Interactive comment on “A national topographic dataset for hydrological modeling over contiguous United States” by Jun Zhang et al.

Replies to Reviewer1:

Fig. 1. Figure 9: (a) the elevation along an example stream segment (shown in c) before and after smoothing applied along the stream divided into segments by dashed lines; (b) the ponding depth along the ma

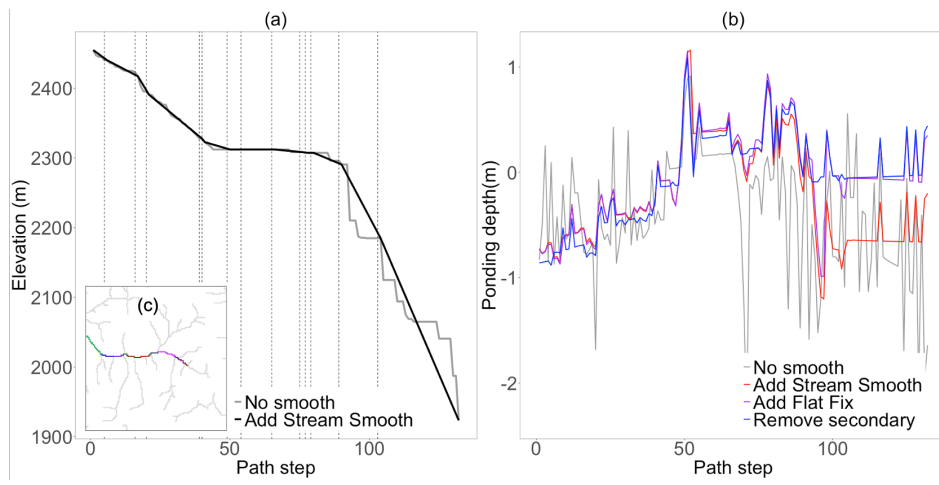
23. Figure 9: These colors are difficult to differentiate in both panels a and b.

Reply: The colors in Figure 9 have been updated as attached.
